PUBLIC WATER AND SEWER PLANS DORSEY RUN INDUSTRIAL CENTER NORTH SIDE REDEVELOPMENT MONTEVIDEO ROAD AND FUTURE DORSEY RUN ROAD ELKRIDGE, HOWARD COUNTY, MD CONTRACT NO. 14-4602-D 1st ELECTION DISTRICT

DES.	ENJ	NO.	REVISION	DATE
DRN.	DAM	5	ADDRESS REDLINE COMMENTS	5-10-16
CHK.	ENJ	4	RETAINING WALL NOTE	4-1-16
		3	ADDRESS REDLINE COMMENTS	1-6-15
		2	ADDRESS REDLINE COMMENTS	1-18-14
DATE:	09/09/12	1	REDLINE REVISIONS - TO USE PVC FOR WATERLINE, NOTES AND ESTIMATE REVISED.	11/20/14

TITLE SHEET

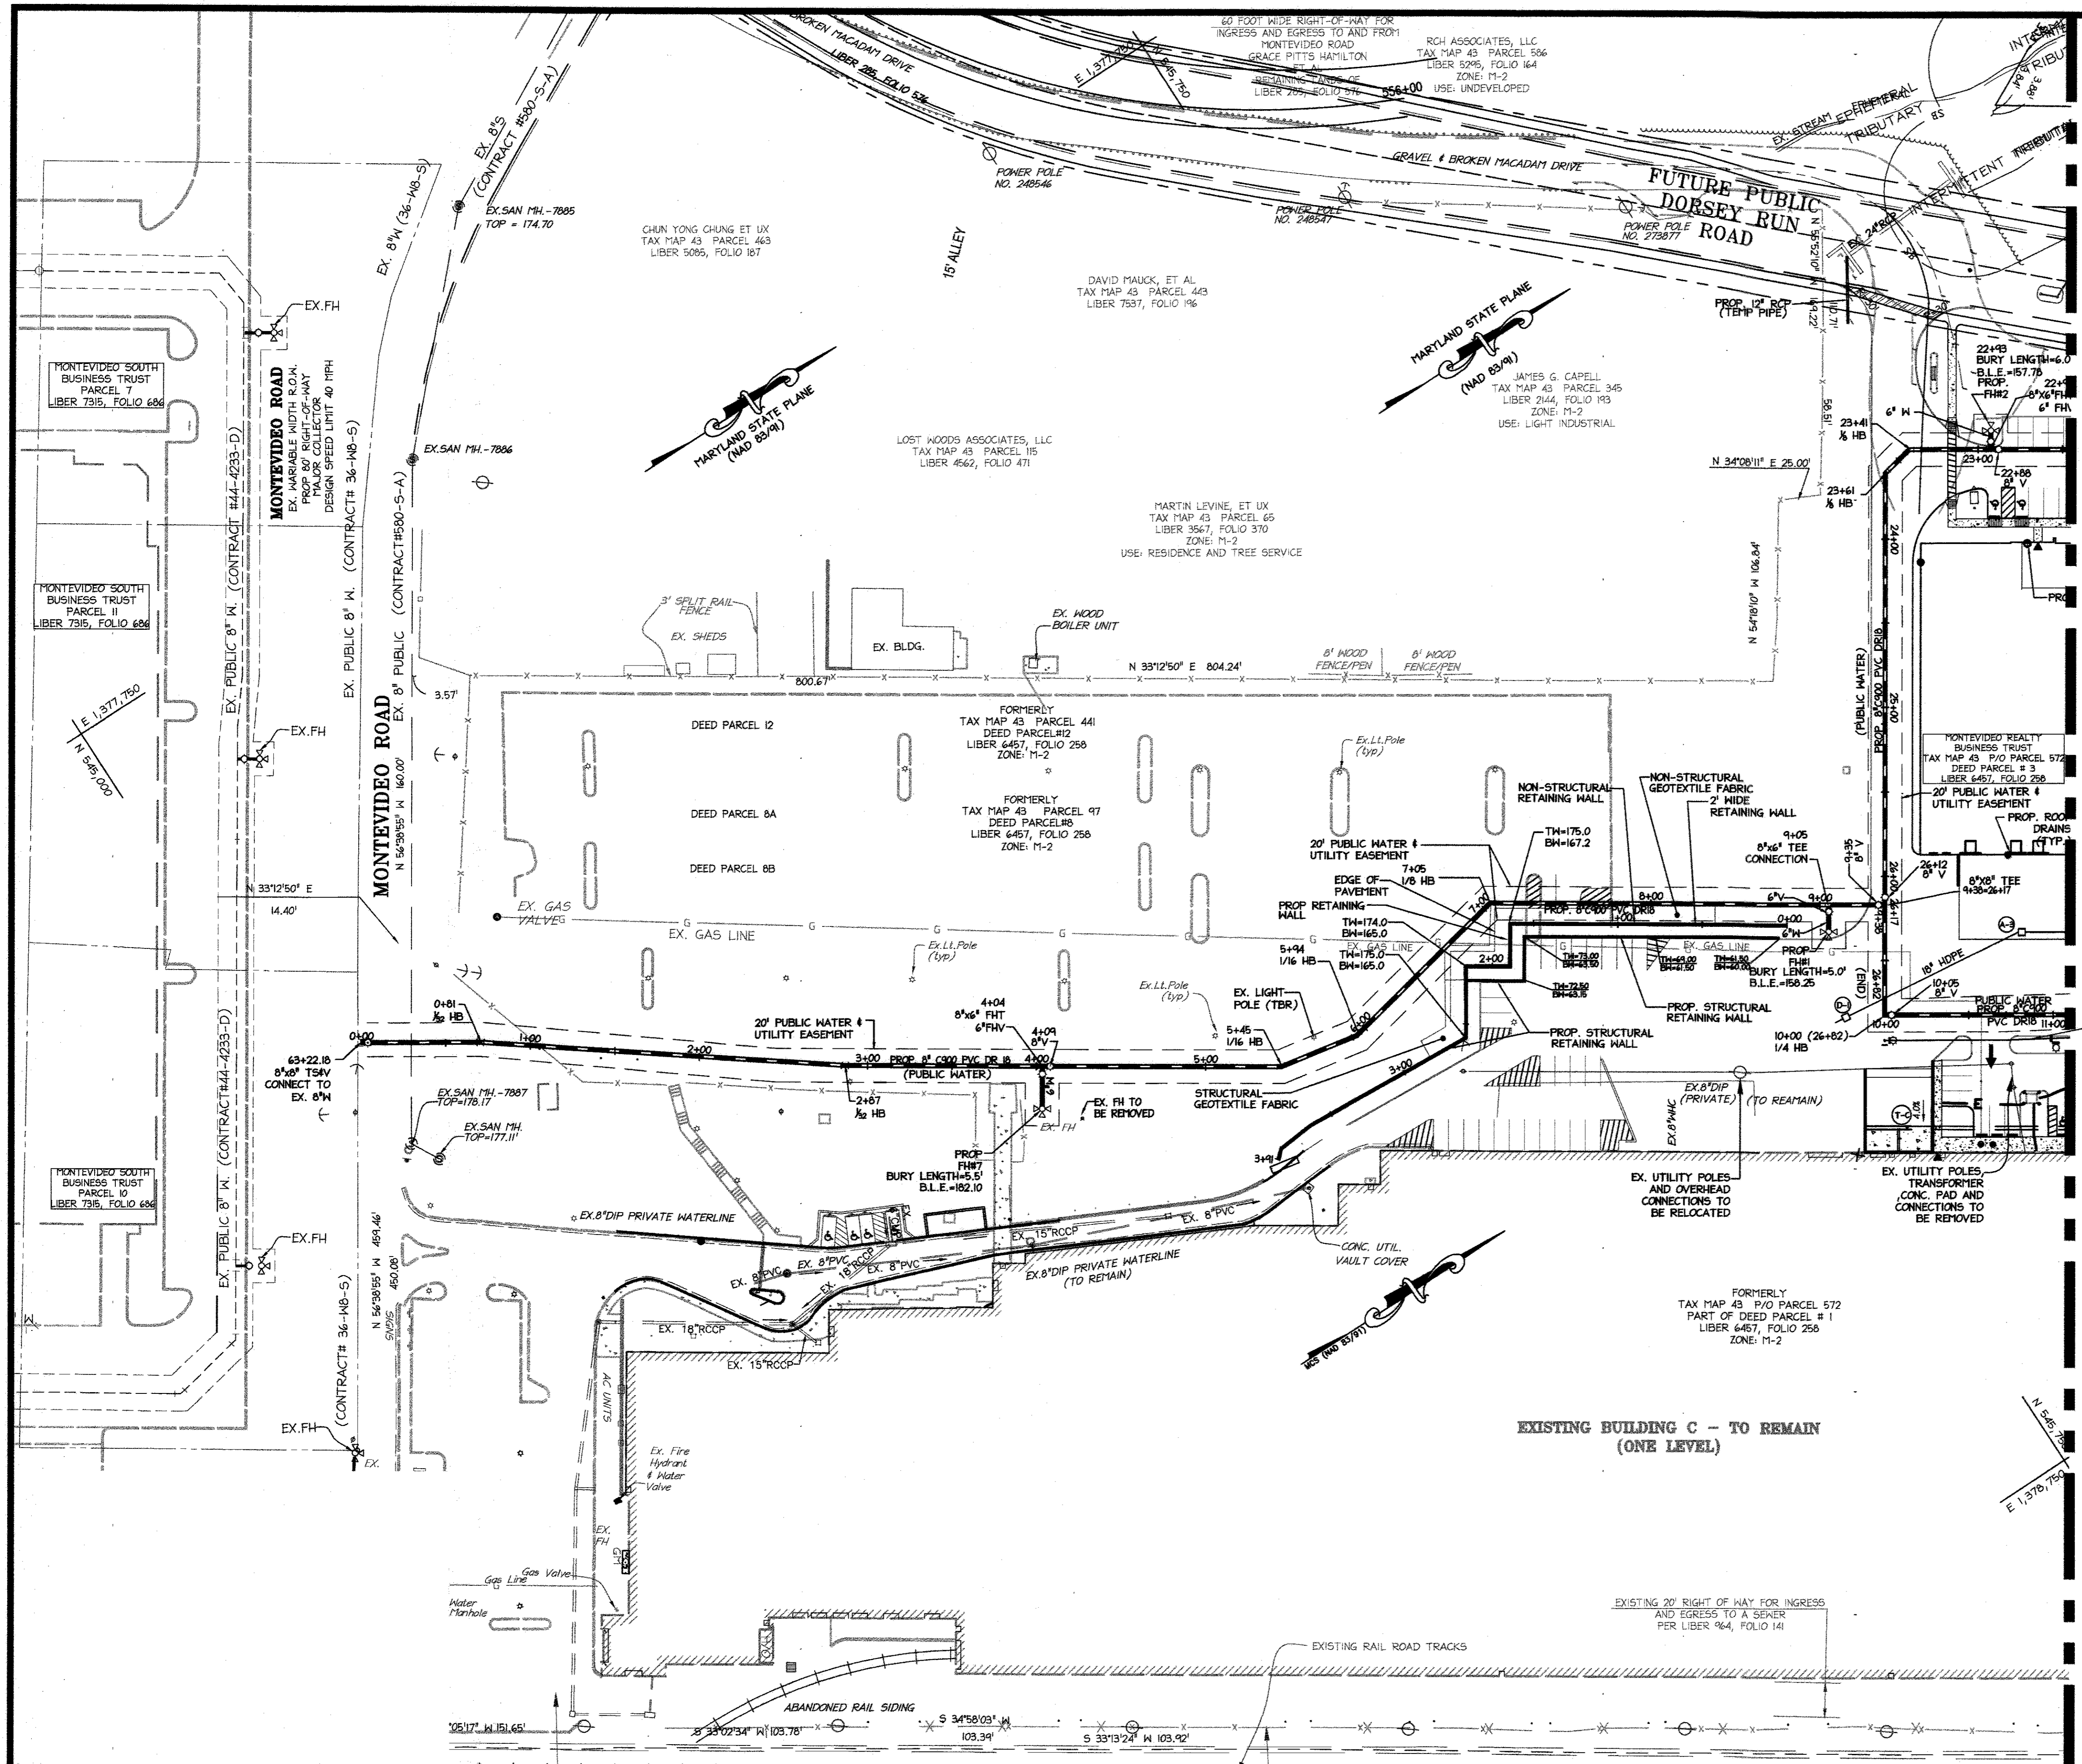
NOTE: REDLINE CHANGES ARE BASED ON DESIGN ACCEPTANCE, NOT CONSTRUCTED WATER MAIN. USING STANDARD PROCEDURES, CID NEEDS TO VERIFY AND SIGN OFF ON IN-FIELD CONDITIONS THROUGH THE AS-BUILT PROCESS AND PER THEIR COMPLIANCE GUIDELINES. BID CANNOT ASSUME RESPONSIBILITY FOR APPROVING IN-FIELD CONDITIONS THAT WERE SUPPOSED TO BE DONE AS AN AS-BUILT APPROVED BY CID.

PUBLIC WATER & SEWER PLANS
 600 SCALE MAP NO. _____ BLOCK NO. _____

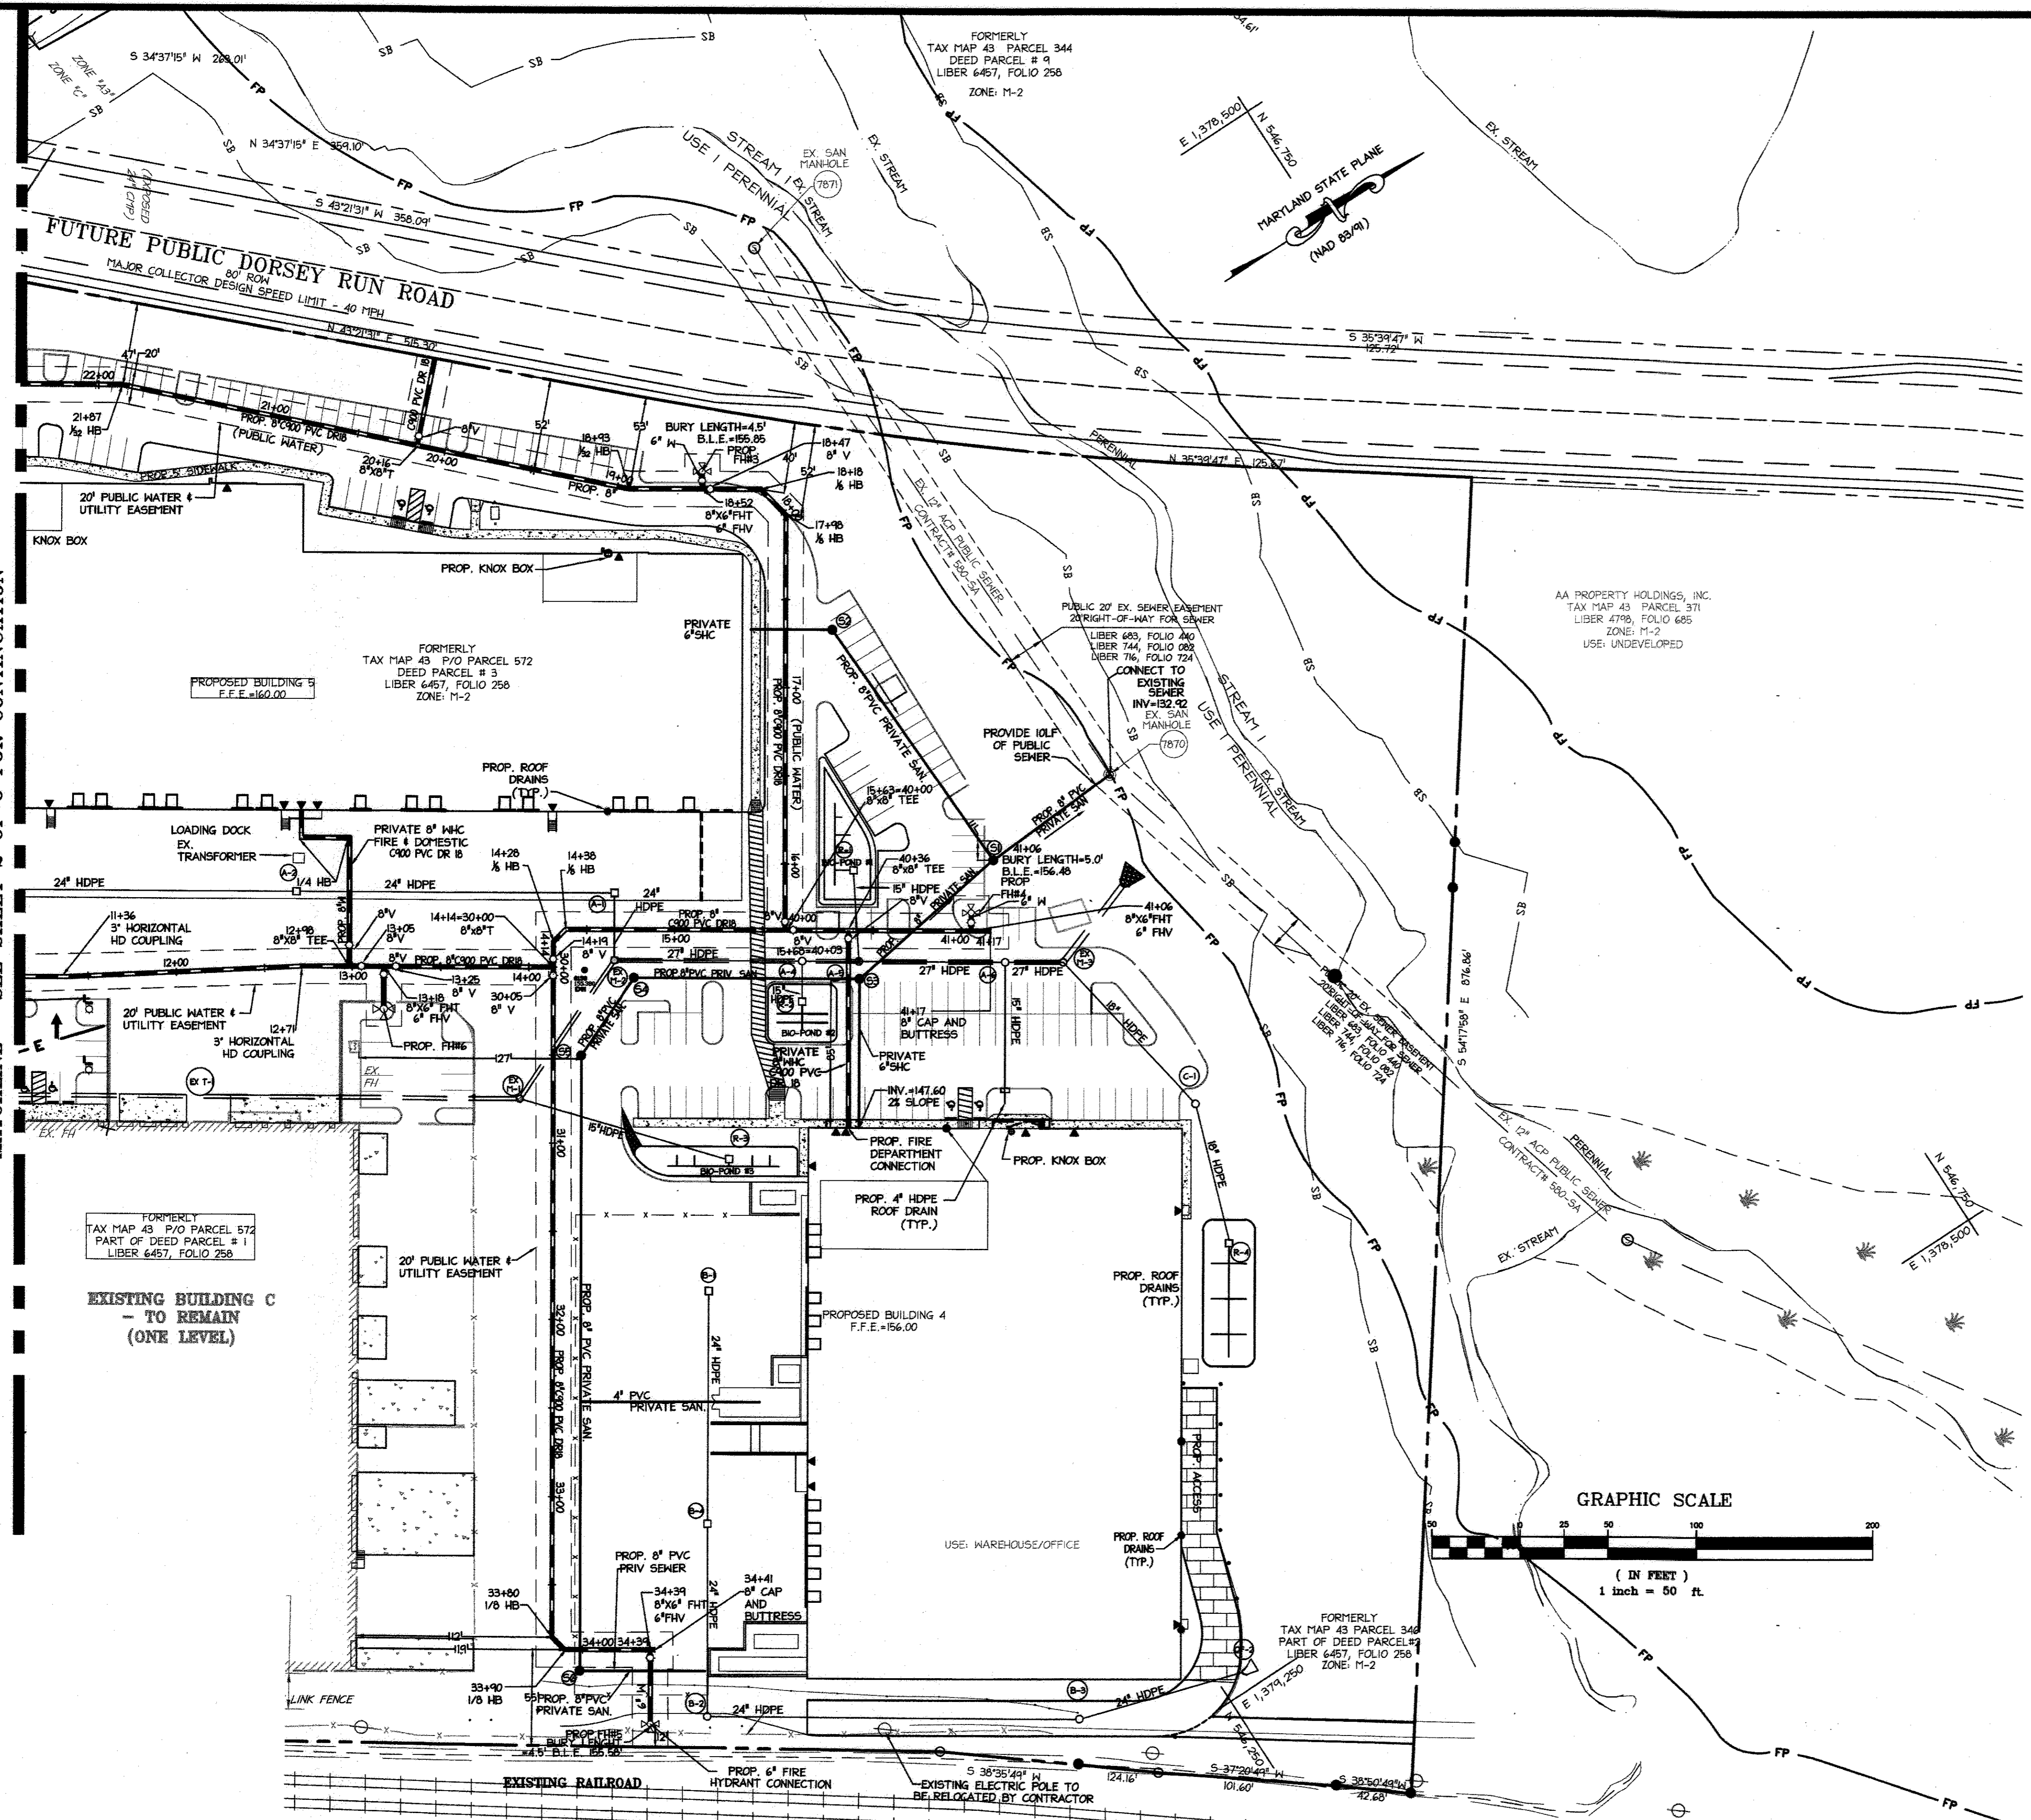
NOTE: REDLINE CHANGES ARE BASED ON DESIGN ACCEPTANCE, NOT CONSTRUCTED WATER MAIN. USING STANDARD PROCEDURES, CID NEEDS TO VERIFY AND SIGN OFF ON IN-FIELD CONDITIONS THROUGH THE AS-BUILT PROCESS AND PER THEIR COMPLIANCE GUIDELINES. BID CANNOT ASSUME RESPONSIBILITY FOR APPROVING IN-FIELD CONDITIONS THAT WERE SUPPOSED TO BE DONE AS AN AS-BUILT APPROVED BY CID.

RETAINING WALL NOTE: PORTIONS OF AN EXISTING RETAINING WALL AND GEGRID ARE TO BE ABANDONED IN PLACE AND ARE DEEMED NON-STRUCTURAL. SEE SHEET 7 FOR LOCATION OF ABANDONED GEGRID.

CAUTION: ABANDONED NON-STRUCTURAL GEGRID FROM ABANDONED RETAINING WALL IS LOCATED WITHIN THE PUBLIC WATER AND UTILITY EASEMENT (BELOW THE INVERT OF THE WATER MAIN) FROM WL STA 6+50 TO WL STA 9+00.

PUBLIC WATER & SEWER PLANS
 600 SCALE MAP NO. BLOCK NO.

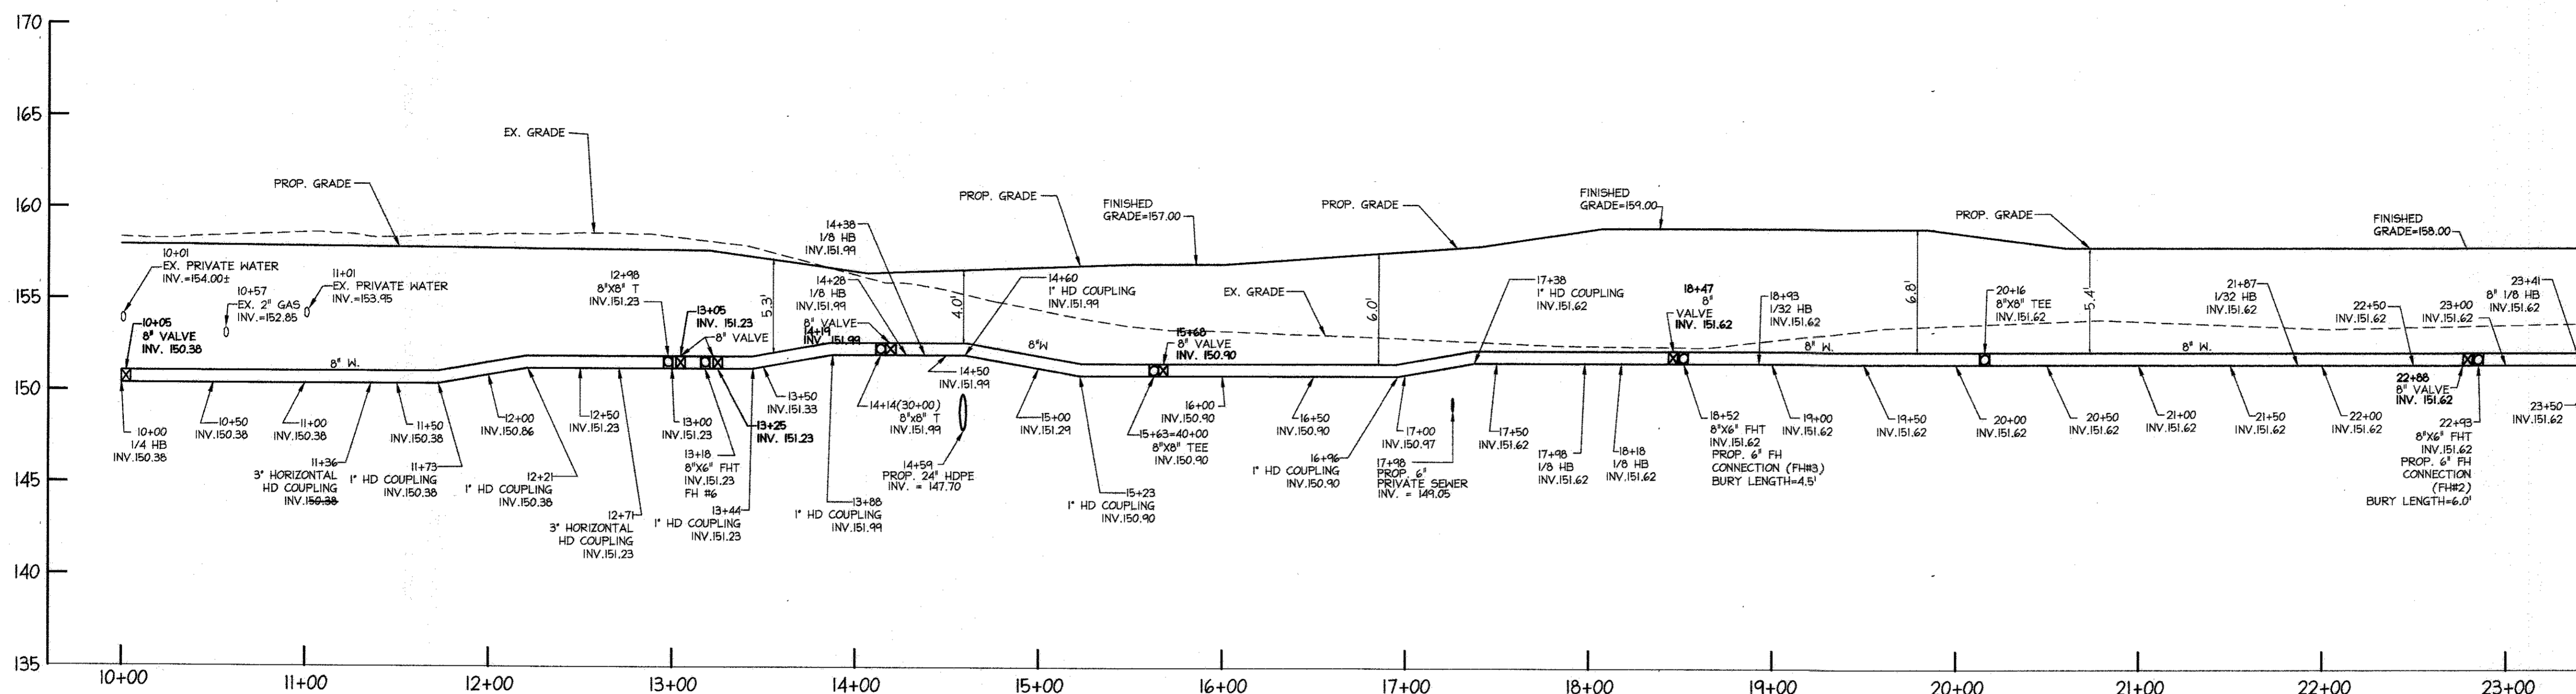
NOTE: REDLINE CHANGES ARE BASED ON DESIGN ACCEPTANCE, NOT CONSTRUCTED WATER MAIN. USING STANDARD PROCEDURES, CID NEEDS TO VERIFY AND SIGN OFF ON IN-FIELD CONDITIONS THROUGH THE AS-BUILT PROCESS AND PER THEIR COMPLIANCE GUIDELINES. CID CANNOT ASSUME RESPONSIBILITY FOR APPROVING IN-FIELD CONDITIONS THAT WERE SUPPOSED TO BE DONE AS AN AS-BUILT APPROVED BY CID.
